DECISION OF THE HISTORIC LANDMARKS COMMISSION

MAJOR HISTORIC DESIGN REVIEW CASE NO.: HIS22-01

SUMMARY: A proposal to replace the exterior windows and add new security lighting and cameras on the exterior of the Anderson Building (c.1900).

2nd Floor Windows Replacement
Anderson Building 201
 275 Court Street NE Salem OR 97301

SHEET:
A2.01

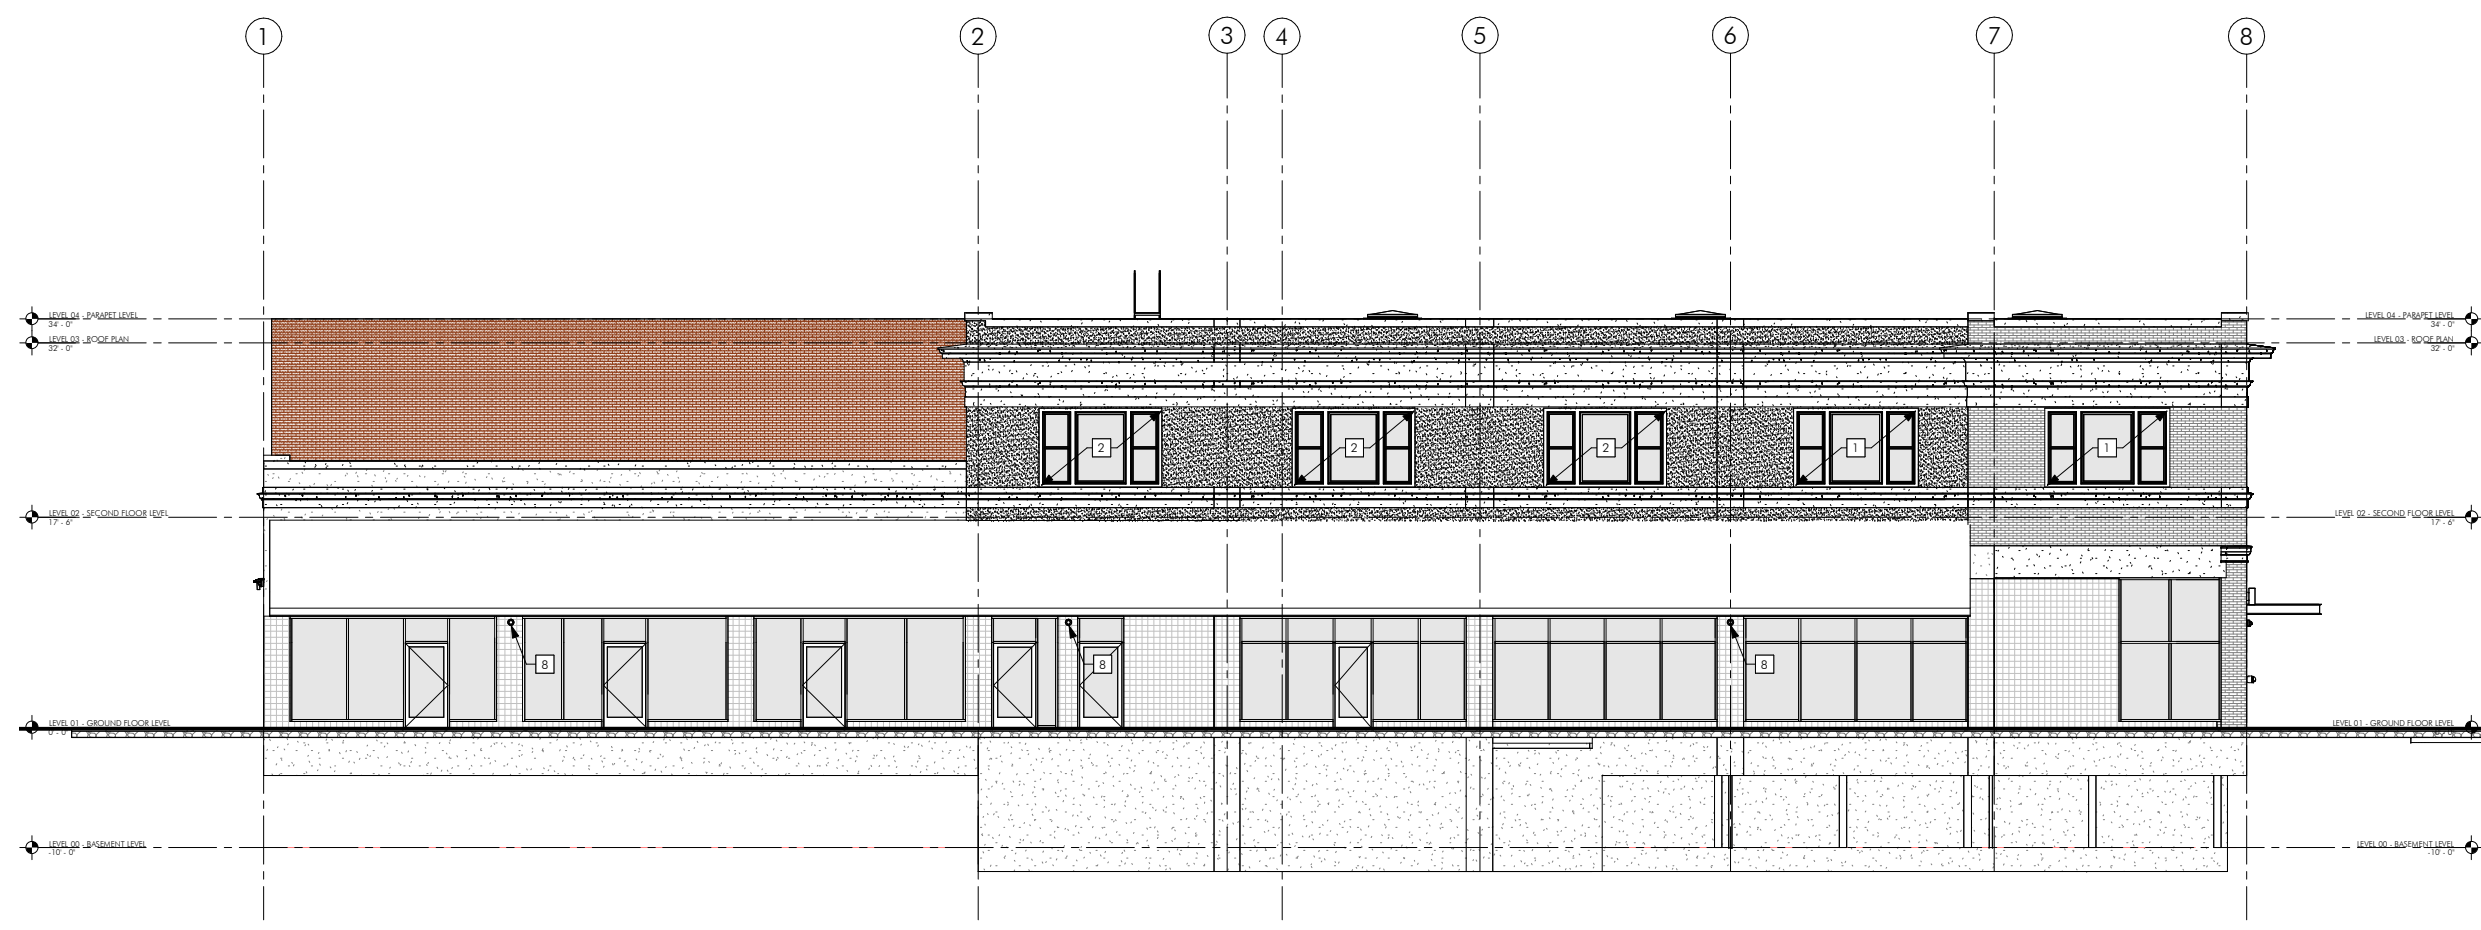
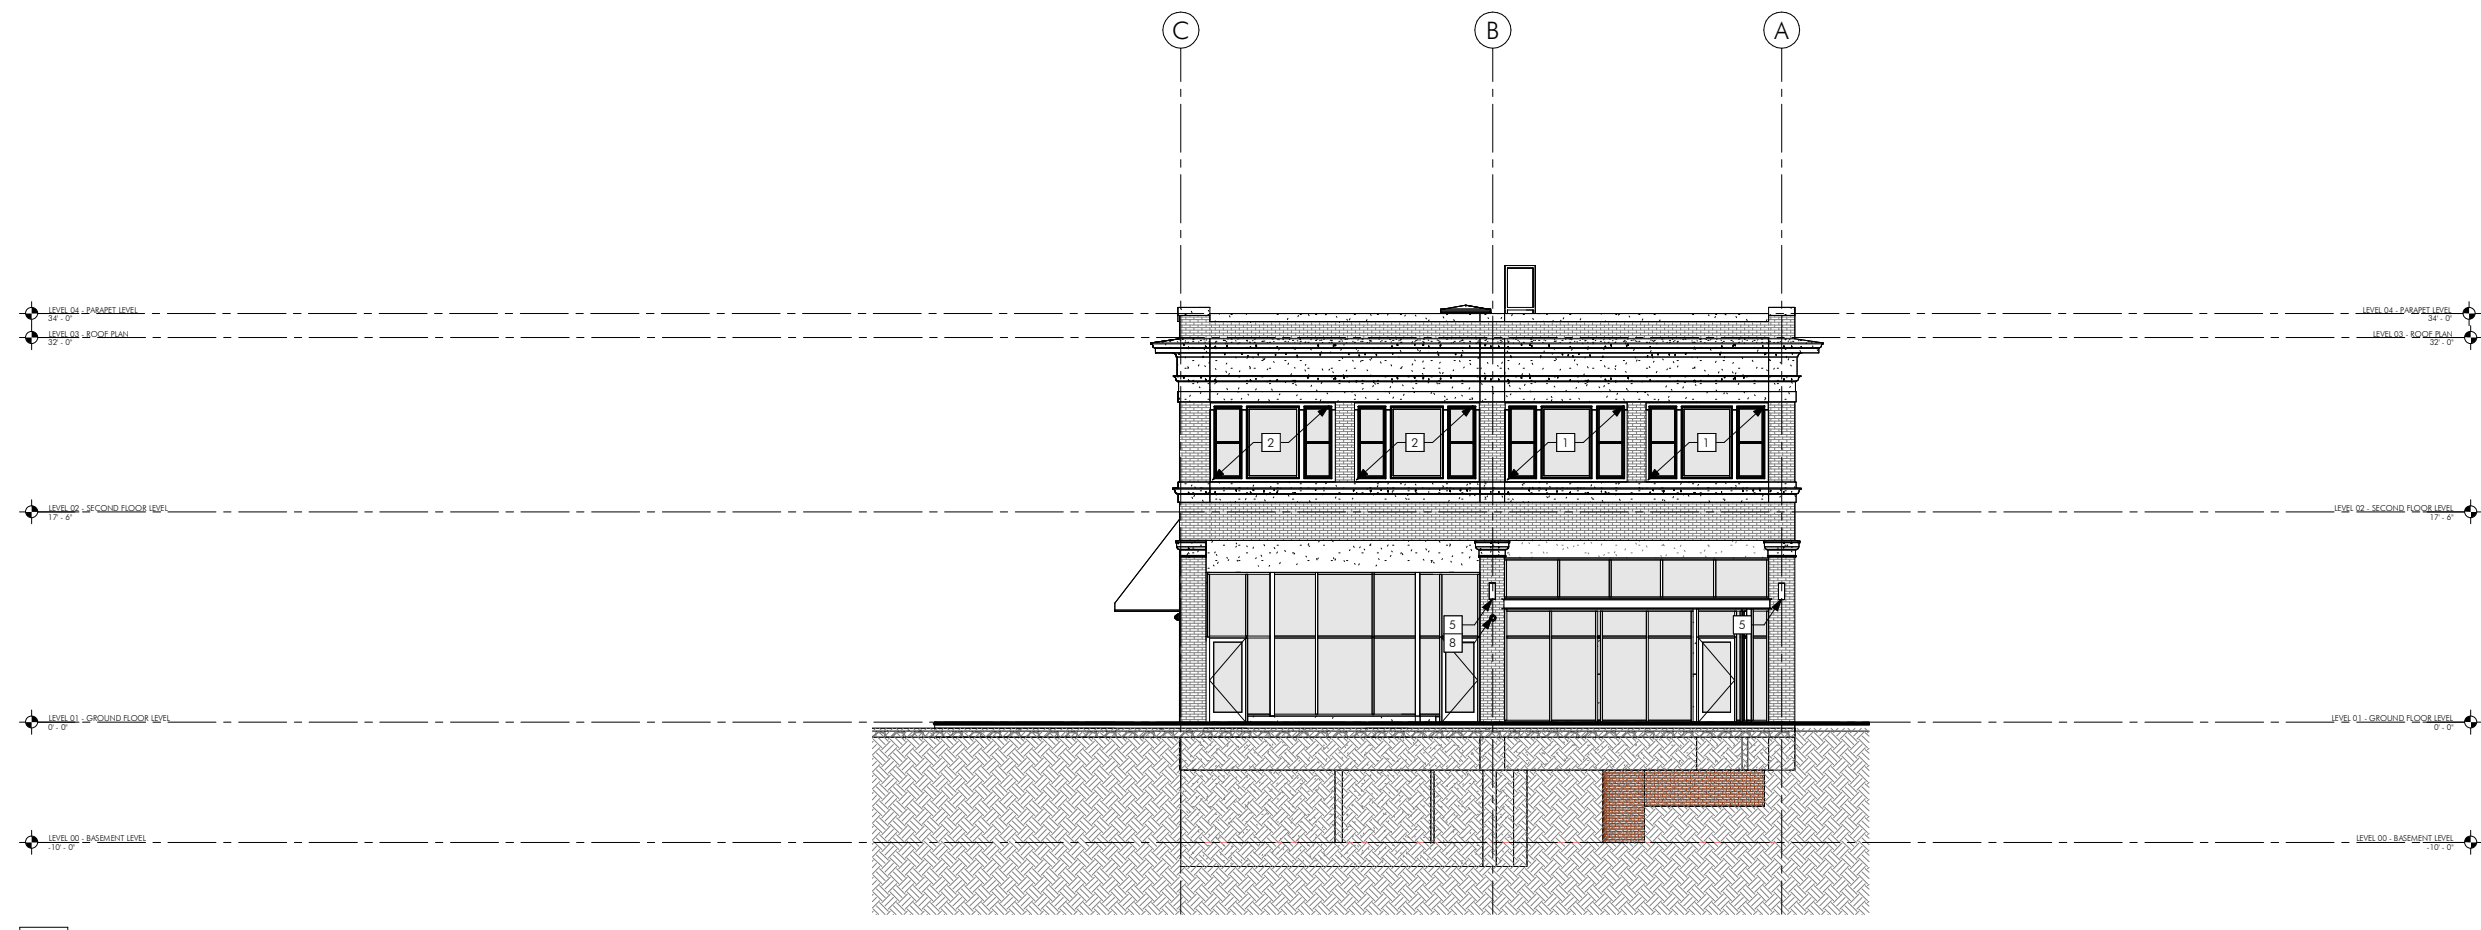
Finding: The proposed new security cameras and the replacement and new security lighting fixtures are located on the rear façade, screened by the existing awning or in an inconspicuous location on the exterior of the Anderson Building. The most visible fixtures are on the east façade fronting Commercial Street. The replacement security light fixtures for the eastern façade are of a 'box' design, where the light shines both up and straight down on the building façade, and where the light fixture appears to be an integral part of the overall building design. The fixtures will be installed into the brick columns, and in order to ensure that the proposal does not adversely impact any original materials on the exterior of the Anderson Building, staff recommends the HLC adopt the following Condition of Approval:

Finding: The applicant is proposing to install new security cameras and lighting at the rear of the Anderson Building and screened by the existing awning on the south façade. The replacement and new fixtures are small in scale, and where visible on the eastern façade, no character defining features are obscured or damaged by their installation. Staff recommends the HLC find that SRC 230.040(j)(2)(B) has been met for this proposal.

Finding: The applicant is proposing to install new security cameras at street level underneath the existing awning, so these cameras will be screened from view facing Court Street NE. The proposed new cameras and replacement security lights are small in scale on the facades fronting Commercial Street NE and the alley at the rear, and while not screened, the new fixtures will not obscure any character defining features. Staff recommends the HLC find that SRC 230.040(j)(2)(F) has been met for this proposal.

Condition 1: The proposed new security cameras and lighting fixtures shall be attached into mortar joints and not into the brick masonry on the columns on the exterior of the Anderson Building.

1 WINDOW ASSEMBLY ELEVATIONS

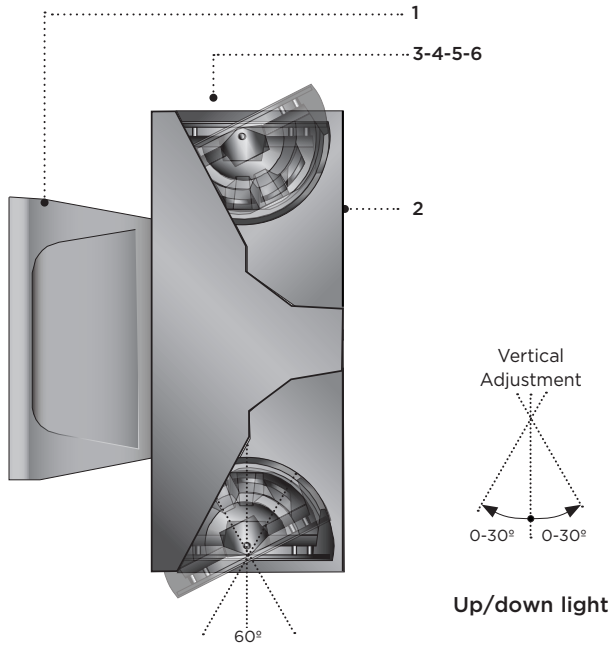
Finding: The applicant is proposing to install replacement windows which match the configuration and design of the 1927 windows on the second-floor windows of the Anderson

Building. The windows will be installed into the existing openings and they will be framed and trimmed with wood, matching the existing to the greatest degree feasible. While the windows will be fiberglass and not wood, the fiberglass is paintable, and therefore will not have the reflective qualities of a more modern window. Staff recommends the HLC find that SRC 230.040(b)(2)(A) has been met for the proposal.

Finding: The applicant is proposing to retain the existing size and shape of the 1927 window openings, and the configuration of the exterior façade of the Anderson Building will not be changed. Staff recommends the HLC find that SRC 230.040(b)(2)(B) has been met for the proposal.
